Monticello Nuclear Generating Plant
Docket No. 50-263
Renewed Facility Operating License No. DPR-22

Subsequent License Renewal Application Response to Request for Additional Information and Request for Confirmation of Information - Set 1 Part 2

RAI GW-5 Groundwater

RAI GW-5:

Figure 3 – Detail View

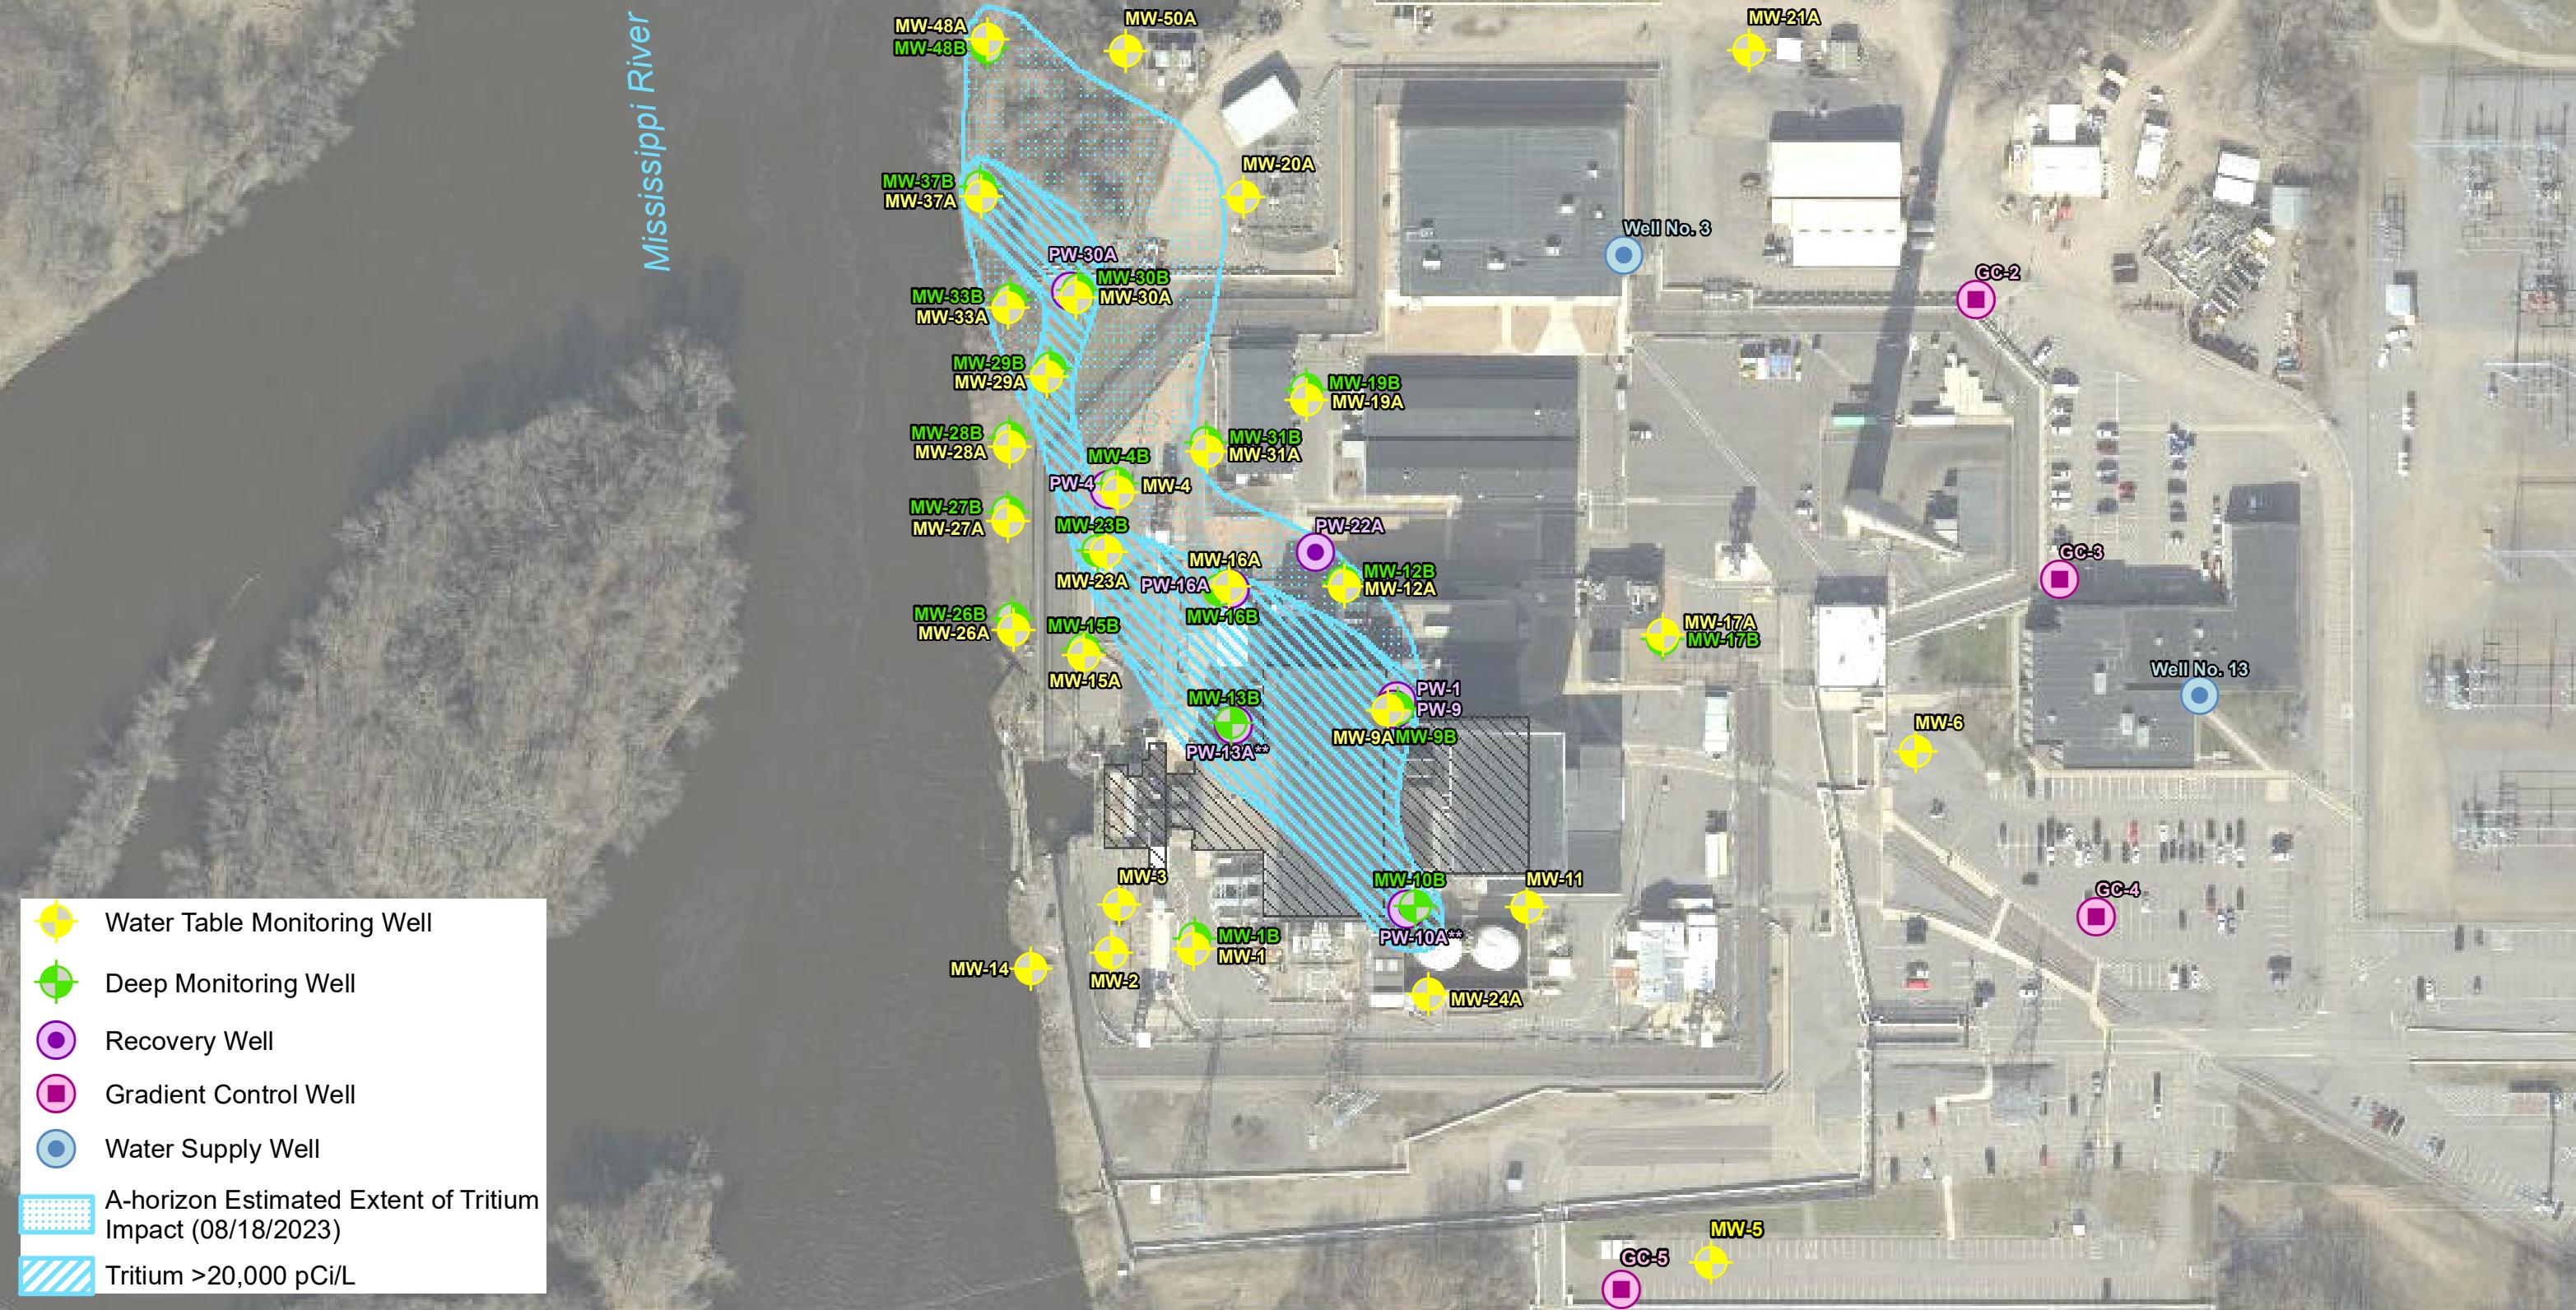
REQUEST: Provide a narrative description of the detection and response to the inadvertent release(s) of tritium into groundwater (first reported in November 2022) through August 18, 2023. This description should include, but not be limited to, the following information:

- (a) The source, volume, and activity of tritium and other radionuclides (if applicable) released, including how these values were estimated,
- (b) Monitoring data that indicated the release(s) had occurred,
- (c) The response taken to stop the release, including a timeline of events,
- (d) A description of and response to the second leak, reported on March 23, 2023,
- (e) A map showing the location of the holding tank that spilled on May 21, 2023, and estimates of the volume spilled and the tritium activity concentration of the holding tank at the time of the spill,
- (f) Maps showing locations of new monitoring wells and tritium recovery wells installed in response to the release(s),
- (g) Maps showing the extent of tritium in groundwater since the occurrence of the release(s), and
- (h) New permits or permit changes required as a result of the response.

Figure 2 – Well Locations and Figure 3 – Detail View – show the location of the new monitoring wells and tritium recovery wells that have been installed as of August 18, 2023.

Figure 3 provides a map of the estimated extent of tritium in groundwater as of August 18, 2023.

Figure 4 – Sheetpile Wall and Gradient Control System

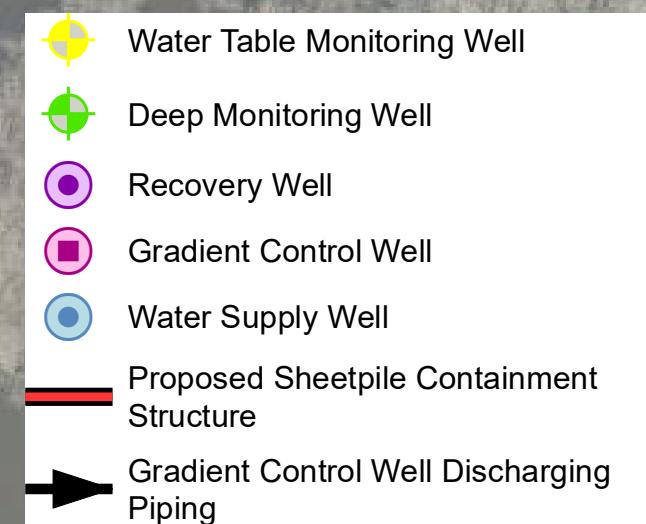
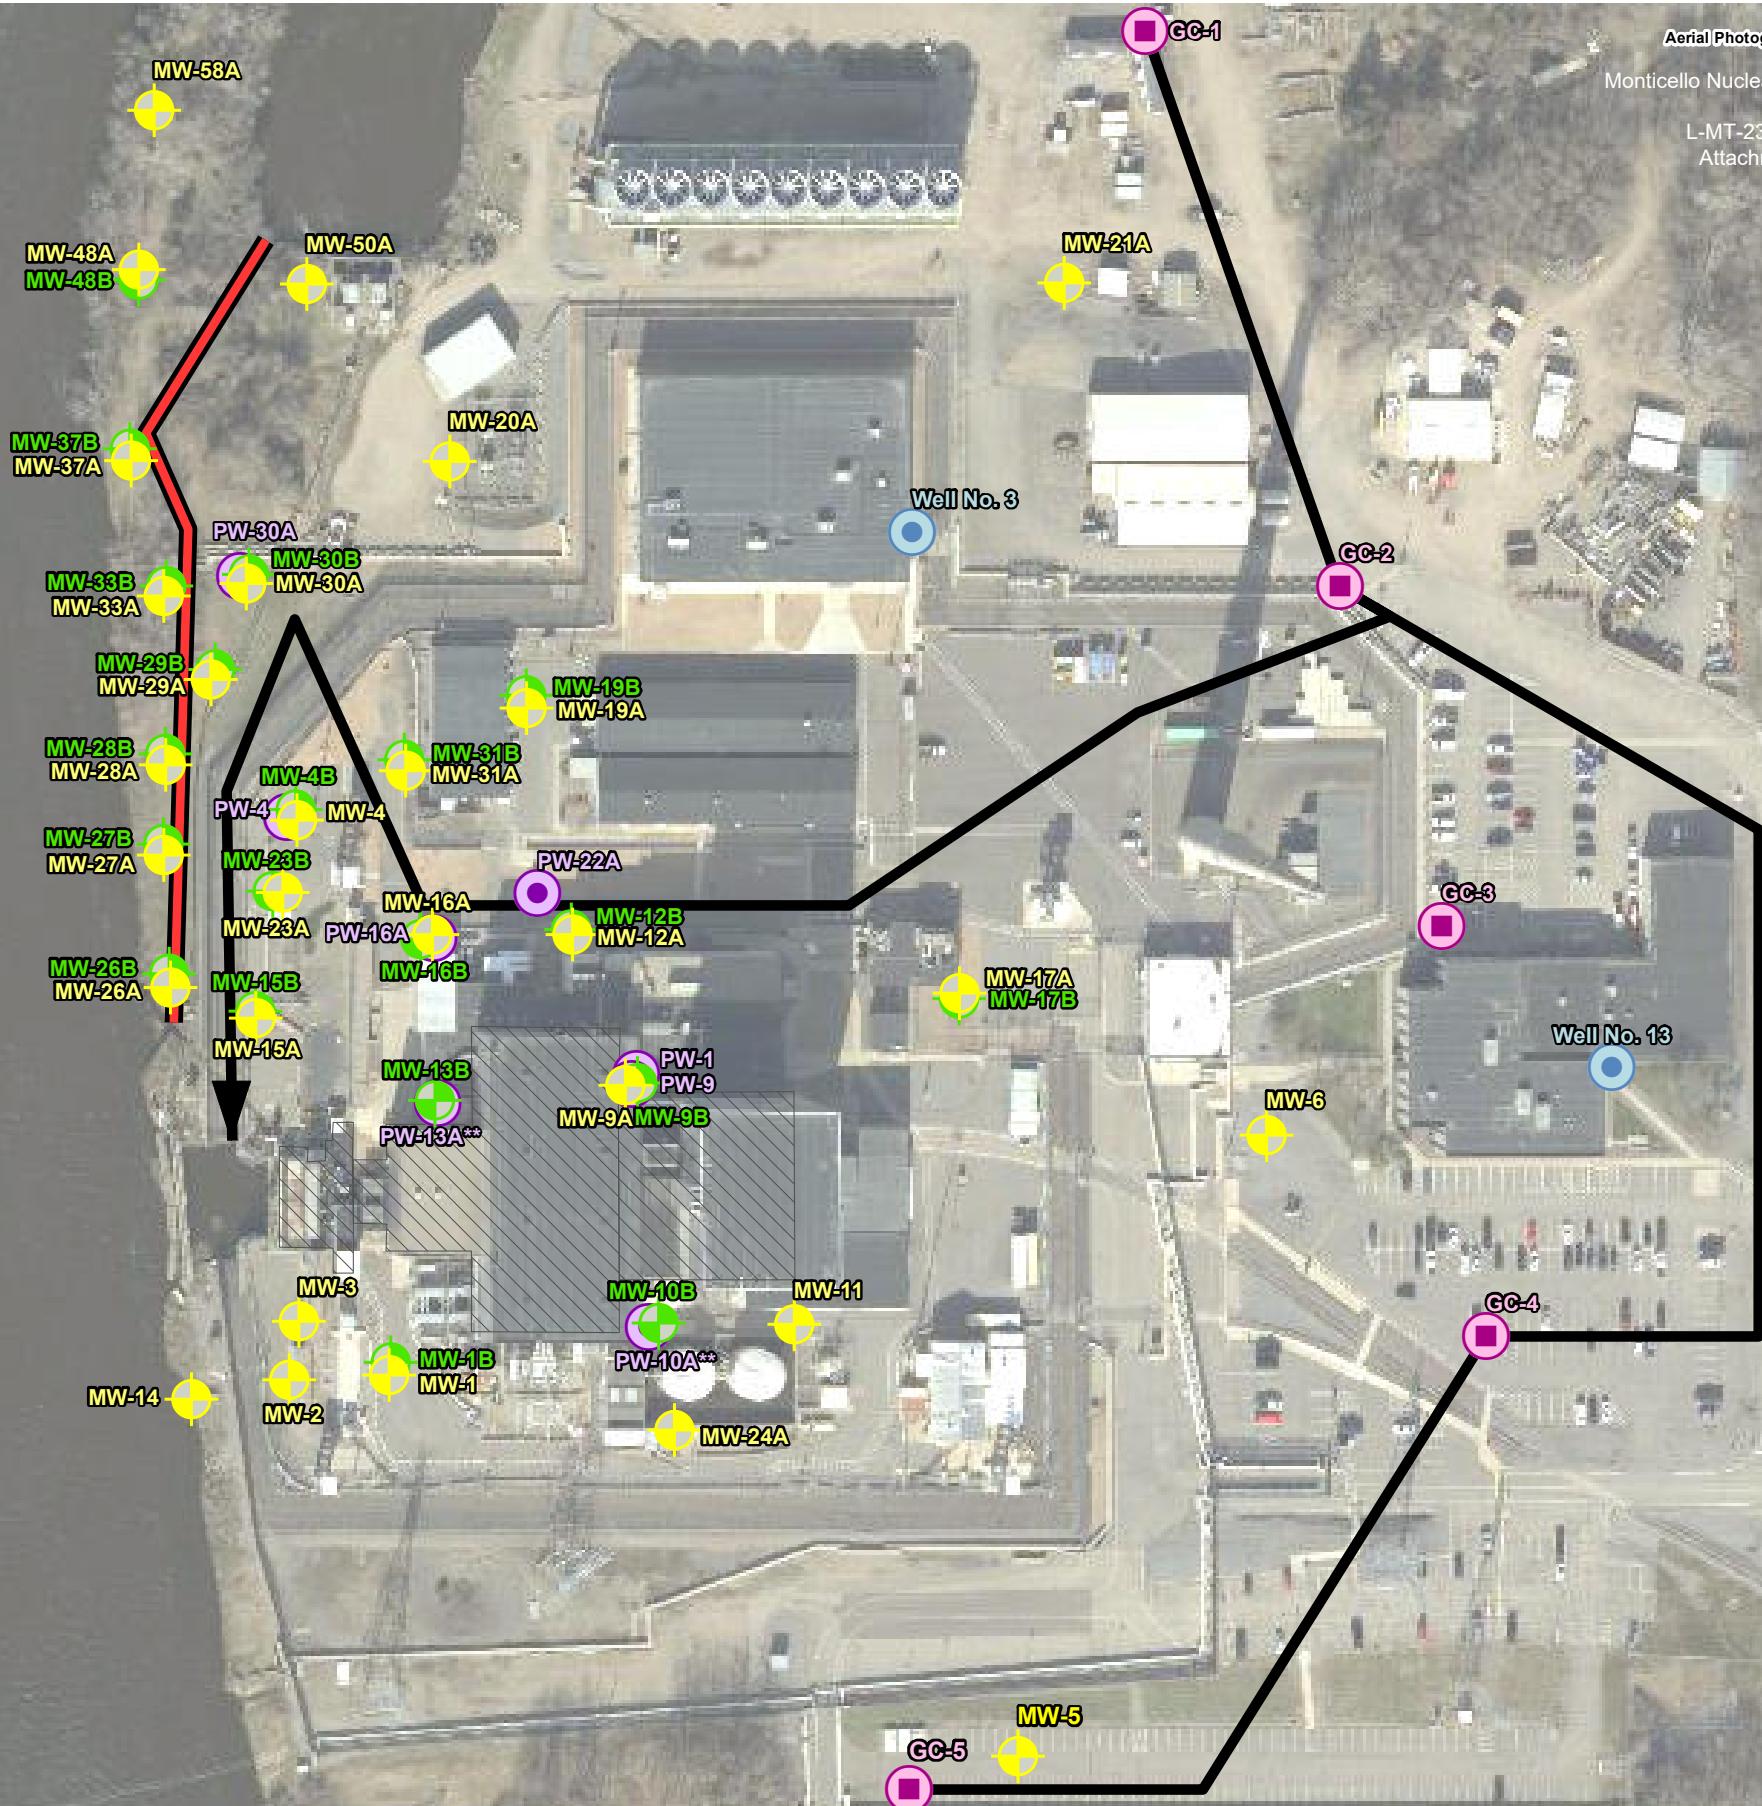
- (g) A description of the current plan, subject to change, for remediation/mitigation of the groundwater tritium contamination, including:
 - location of the cutoff wall,

- locations of hydraulic control pumping wells,
 - estimated pumping rates of the hydraulic control pumping wells,
 - disposition of the water pumped for hydraulic control,

- criteria to terminate pumping of tritium recovery wells and hydraulic control wells, and
 - estimated time to remediate the tritium contamination.

As of August 18, 2023, Figure 4 shows the approximate location of the sheetpile containment structure (cutoff wall) and the proposed approximate location for the gradient control wells and discharge piping.

The estimated pumping rates for the gradient control wells are 100-200 gallons per minute. The rates will adjust based on river level and hydraulic conditions at the station (i.e., drought versus flooding). The gradient control wells will be issued a water appropriation permit by Minnesota Department of Natural Resources. The gradient control wells will likely be discharged into the intake as shown in Figure 4.
